Planning Commission

Staff Report

Case No:	14zone1058
Project Name:	EK Offices
Location:	4011 Fern Valley Road
Owner(s):	Esther Baldeon and Krlos Hidalgo
Applicant:	Esther Baldeon and Krlos Hidalgo
Jurisdiction:	Louisville Metro
Council District:	2-Barbara Shanklin
Case Manager:	Julia Williams, RLA, AICP, Planning Supervisor

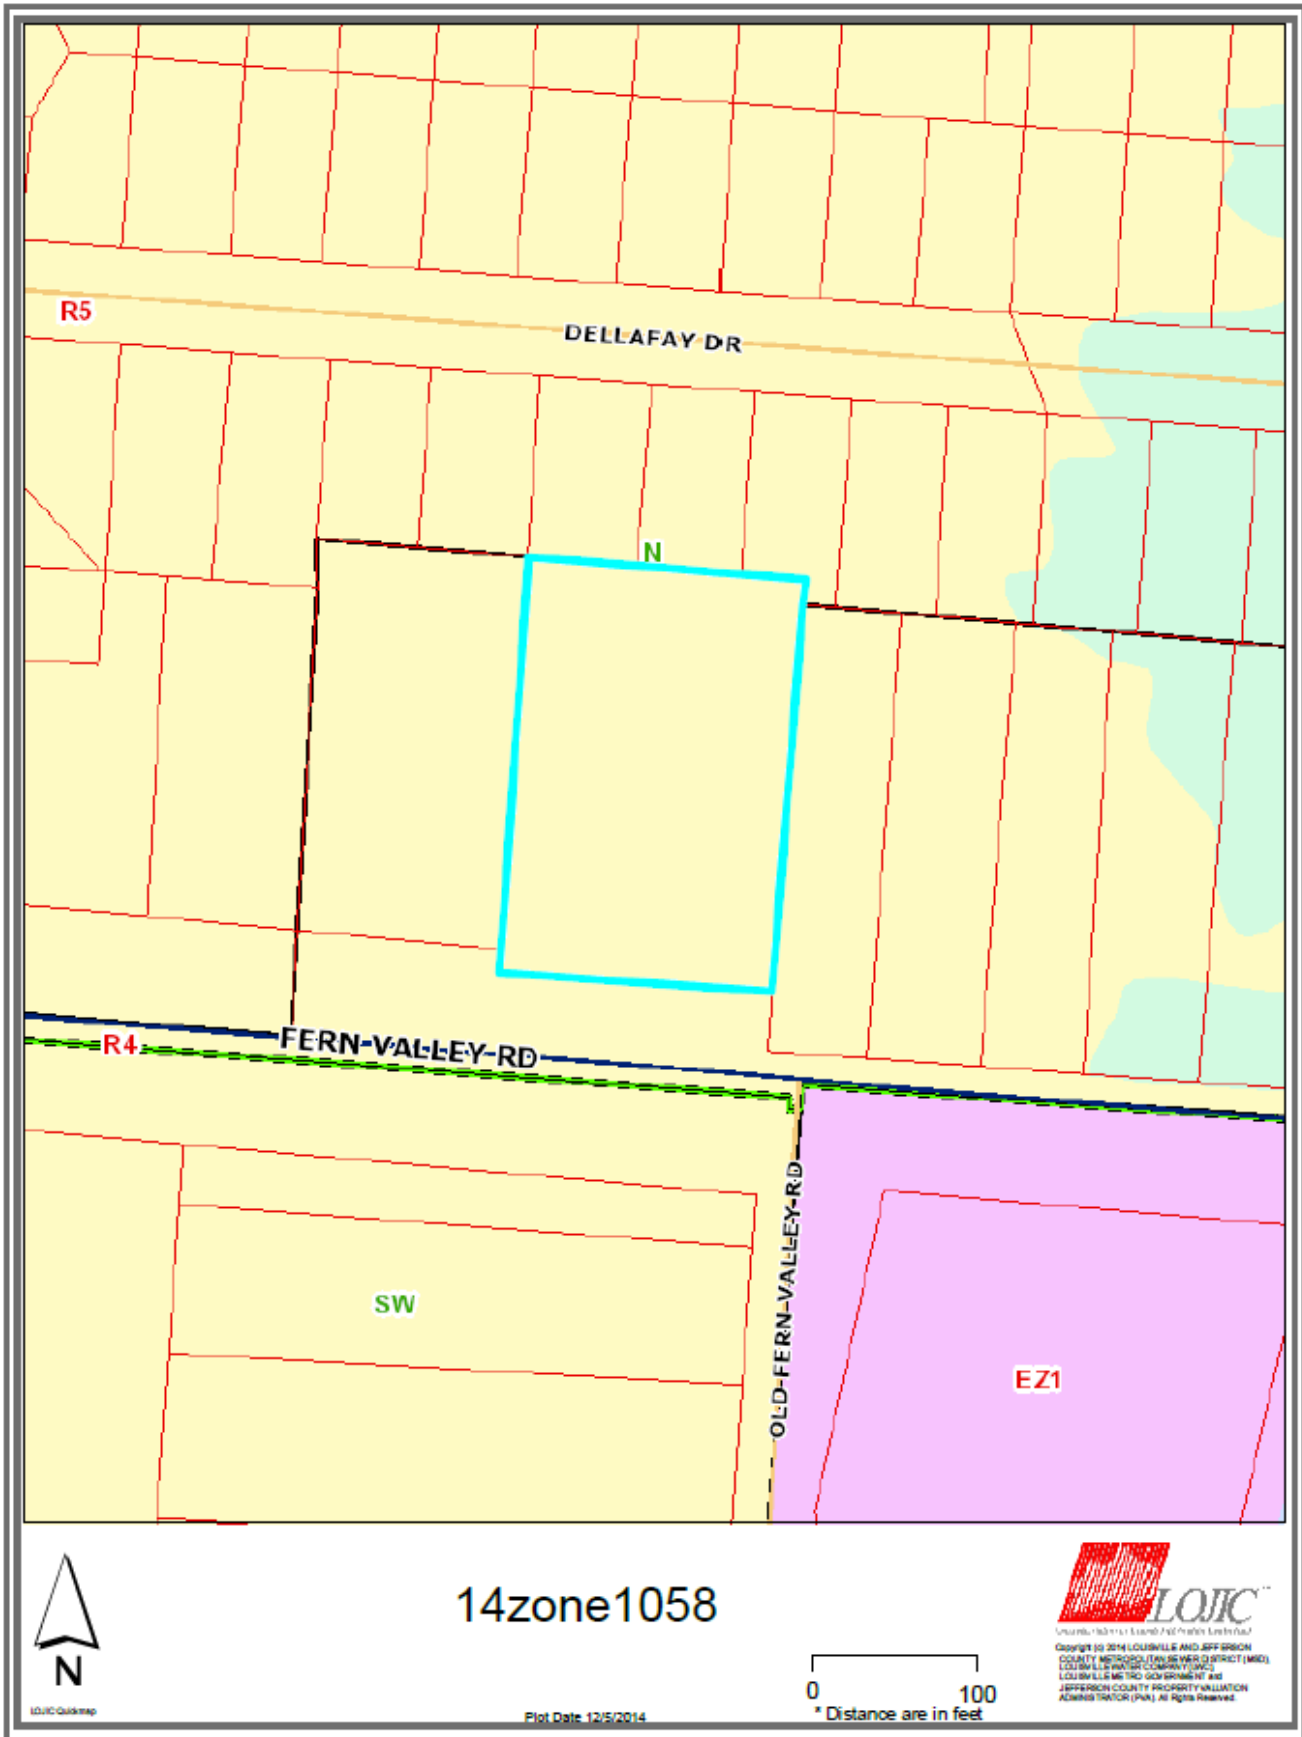
The proposal is to use an existing house as an office where 10 parking spaces are proposed. There are currently 2 access points to Fern Valley Road. One of those access points is to be closed where the other will be expanded to accommodate a 2 way entrance/exit.

The proposal does not share entrances with adjacent uses because all the adjacent uses are residential. Should the adjacent properties develop non-residentially, cross access will be made. There is an existing sidewalk along the frontage. The site is not served by transit. Easy access can be made by vehicles. The proposal is a non-residential expansion into an existing residential area. Much of the site will remain unchanged except for the removal of a curb cut and expansion of the entrance and parking.
